Re: Conditional Use Permit Application
Property at Farmview Road

Re: Conditional Use Permit request by Mega Builders, LLC, dated December 20, 2011, for a Multi-Family Development at Farmview Road, Christiansburg

RE: Mega Builders, LLC
Multi-Family Development – Farmview Road

MEGA BUILDERS, LLC MULTI-FAMILY DEVELOPMENT FARMVIEW ROAD

MEGA BUILDERS
OVERALL PLAN
TOWN OF CHRISTIANSBURG
MONTGOMERY COUNTY, VIRGINIA

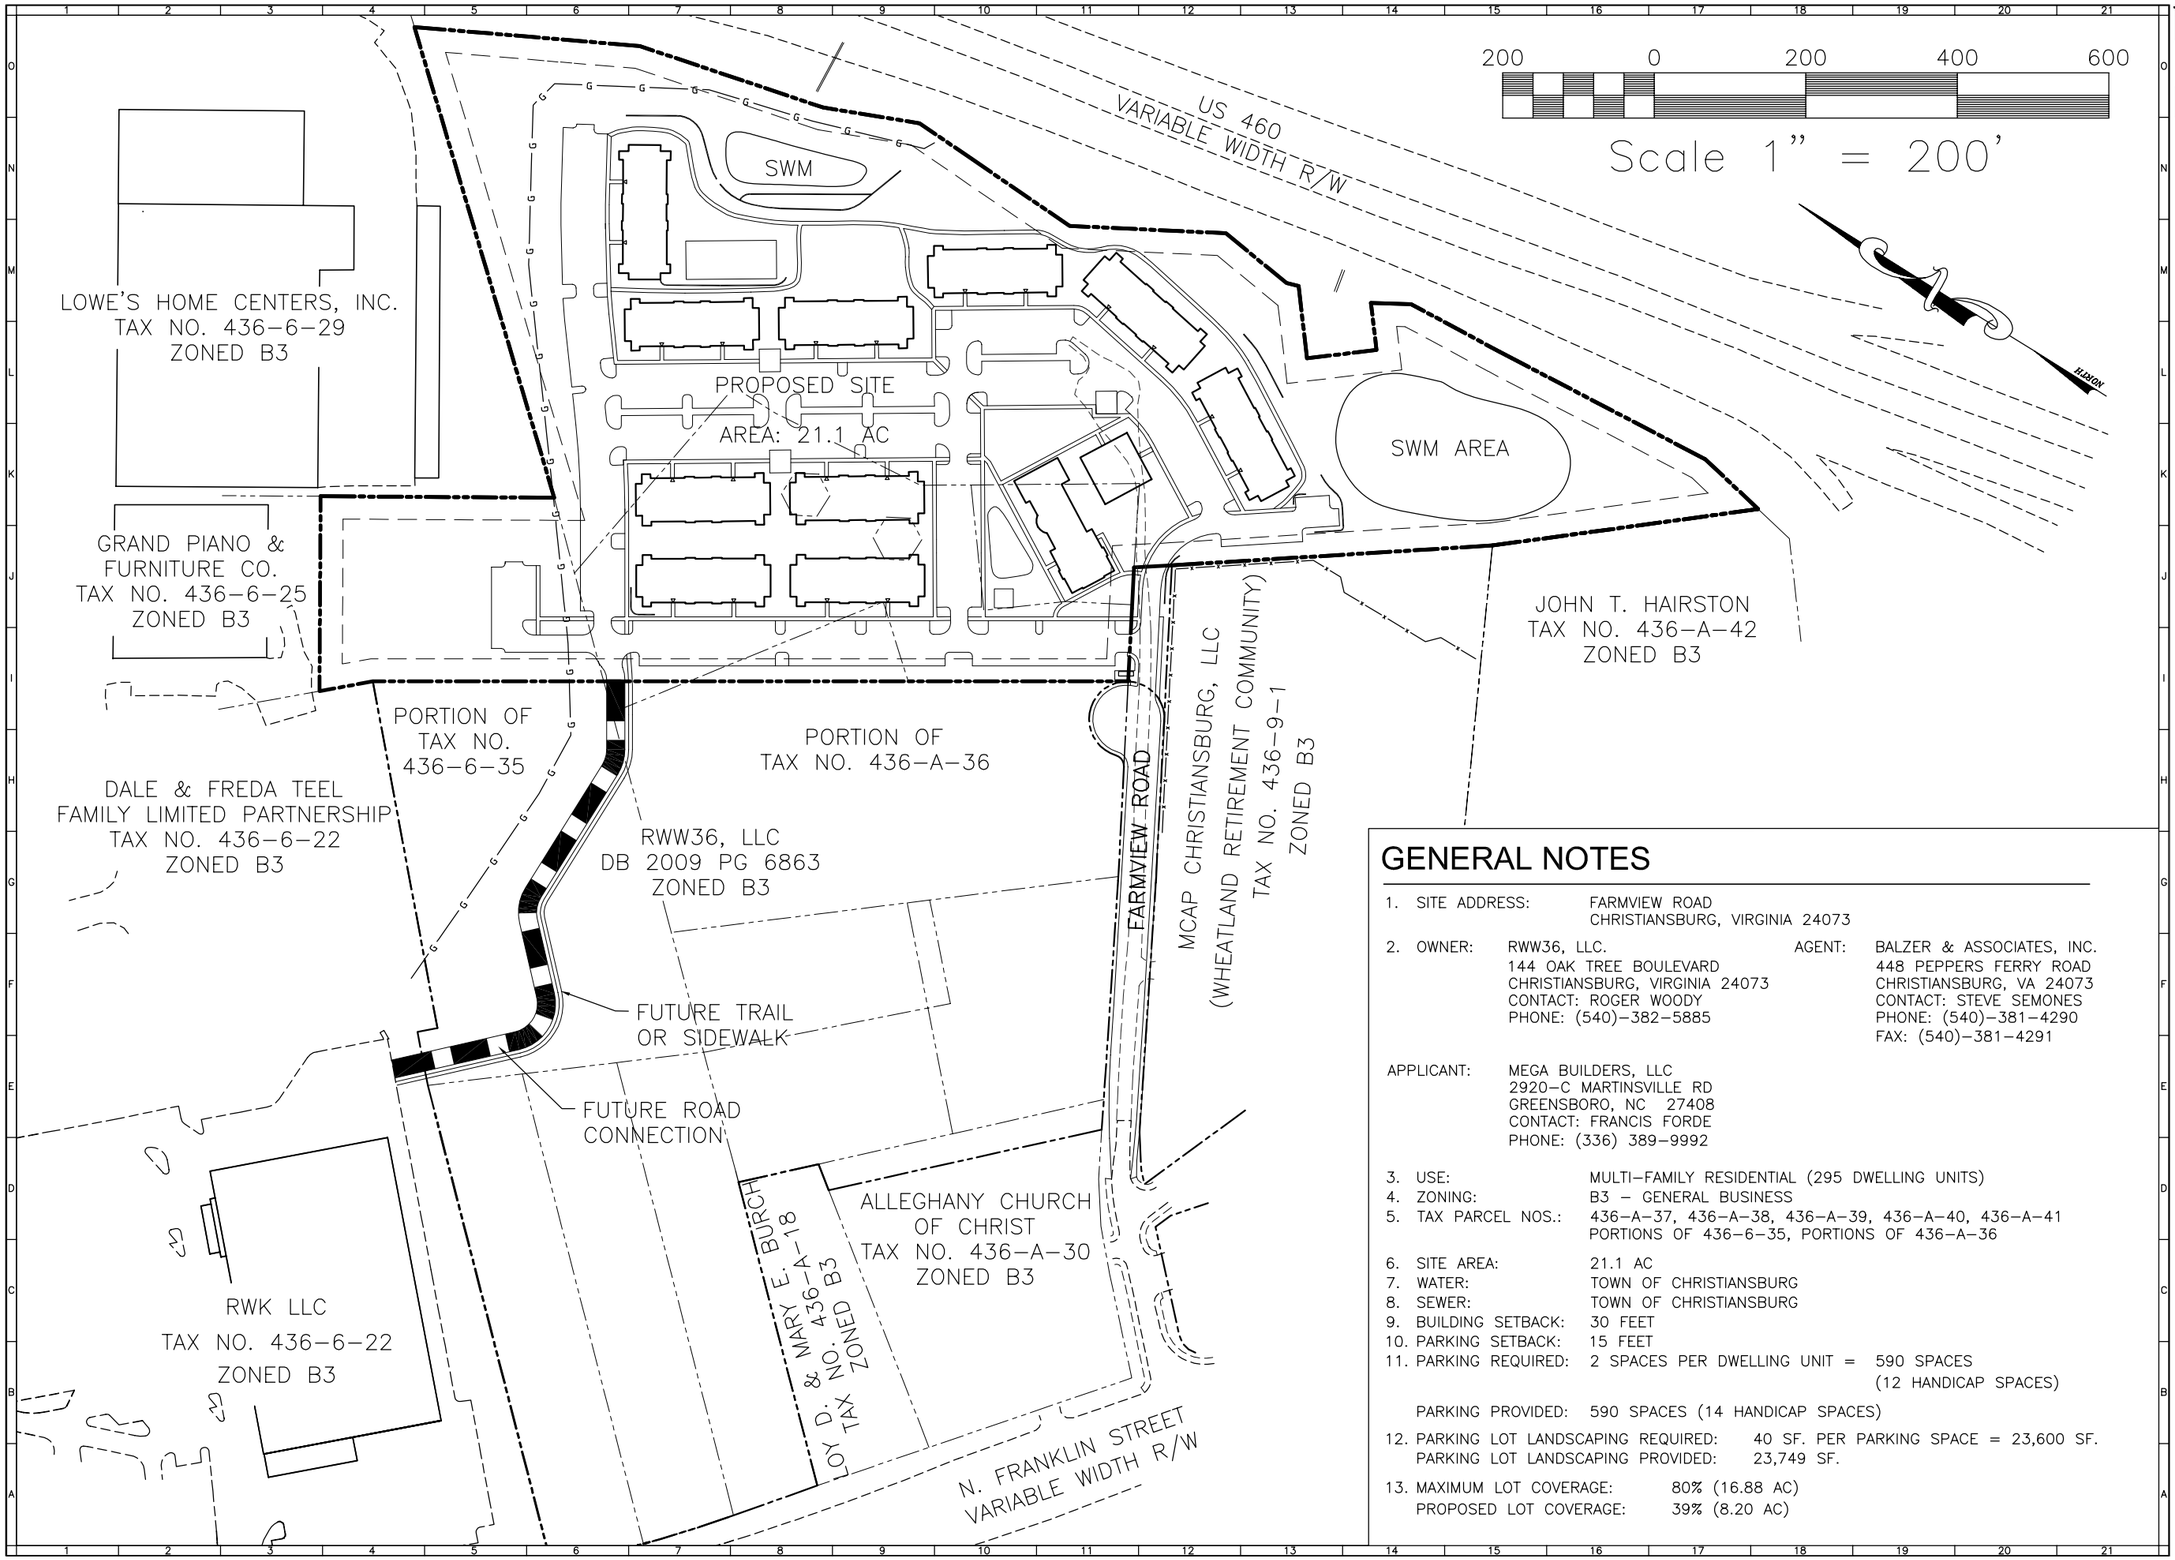
I have updated our application material and concept plan to reflect changes we have made to this project per the comments received from staff, the Planning Commission and our neighbors. I did want to include in this cover letter some of the specific requests and how we have addressed them concerning traffic and pedestrian access.

- A sidewalk has been shown along the Wheatland side of Farmview Road. This will be constructed with Phase I along with the Farmview Road improvements. This sidewalk will tie into the existing sidewalk infrastructure at the intersection.
- A sidewalk/trail has been shown parallel to the future road connection to Kmart. This sidewalk will begin to strengthen the pedestrian access to the existing commercial areas and future commercial development.

1. The property shall be developed in substantial conformance to the concept plan prepared by Balzer & Associates, Inc. and dated 12-20-2011 and revised 1-27-2012.
